**Figure 7.2-10
Groundwater Elevations on the
Auburn Wetland Mitigation Site
(March 8, 2000)**

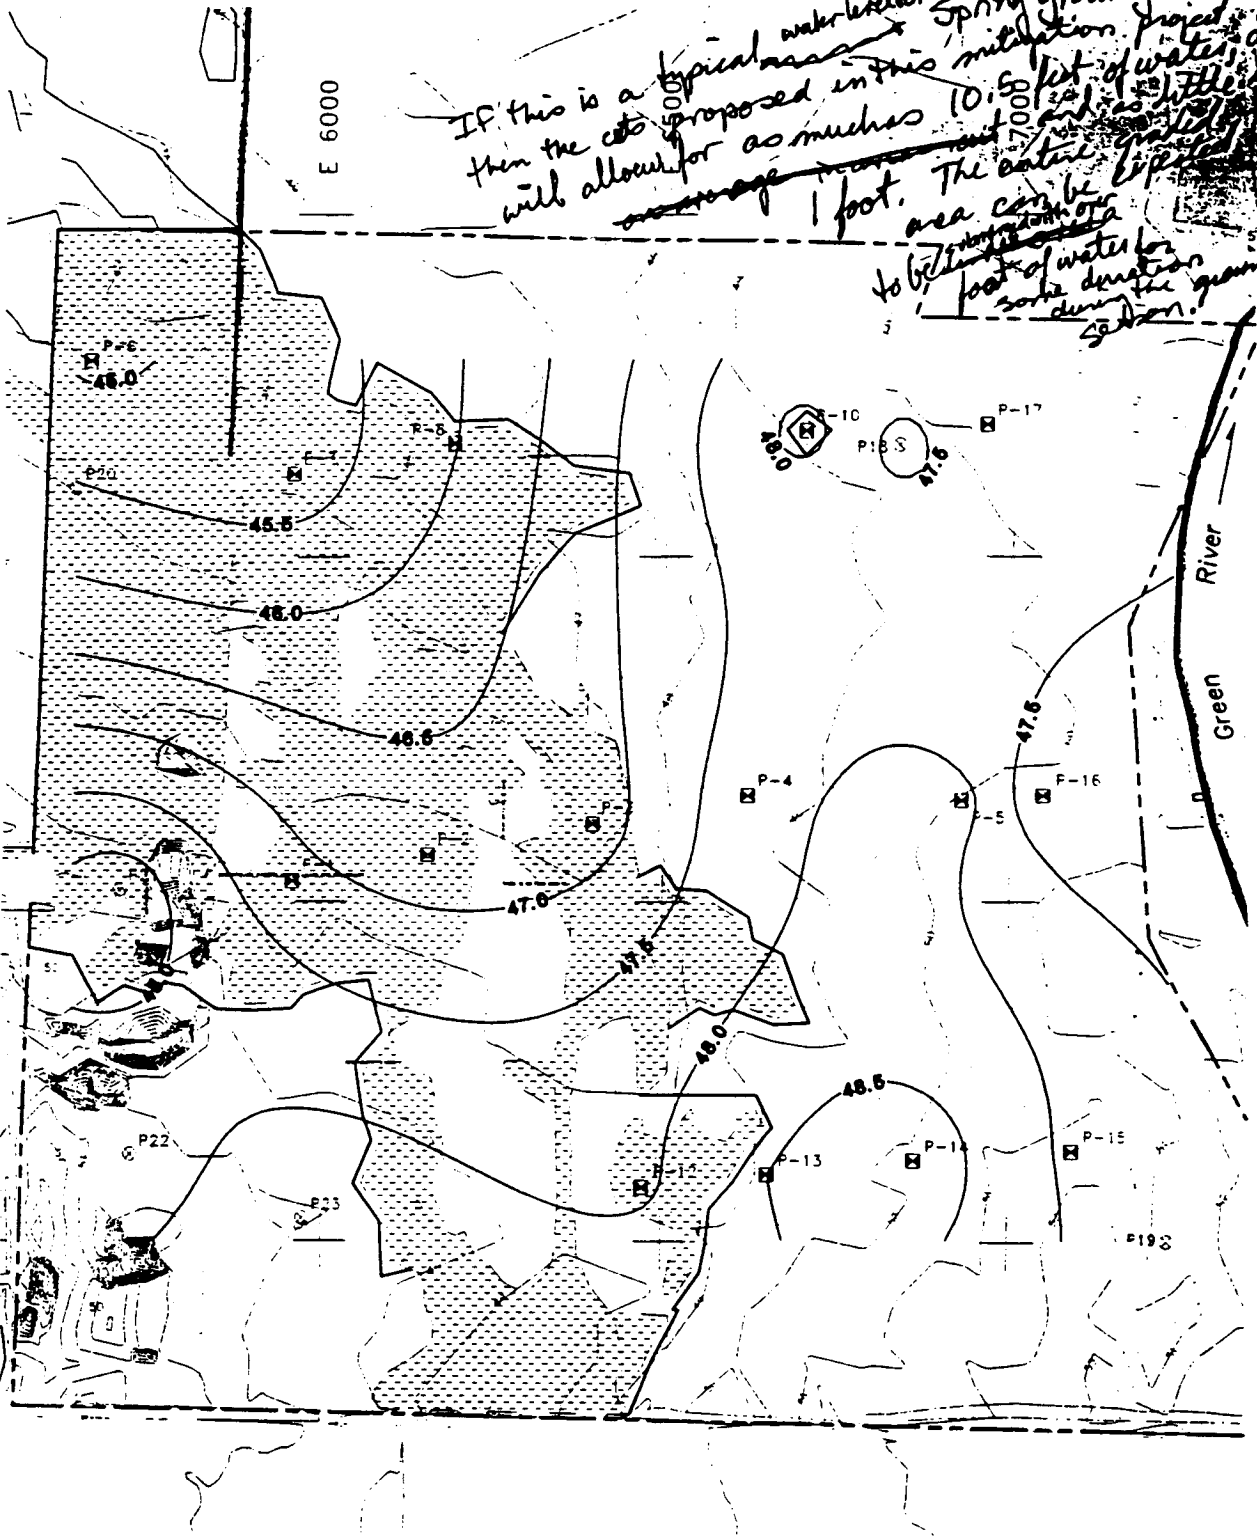
IF this is a typical water-level for Spring growing season then the site proposed in this mitigation project will allow for as much as 10.5 foot of water, and average ~~more~~ out ~~of~~ and as little as 1 foot. The entire riparian area can be expected to be inundated for some duration during the growing season.
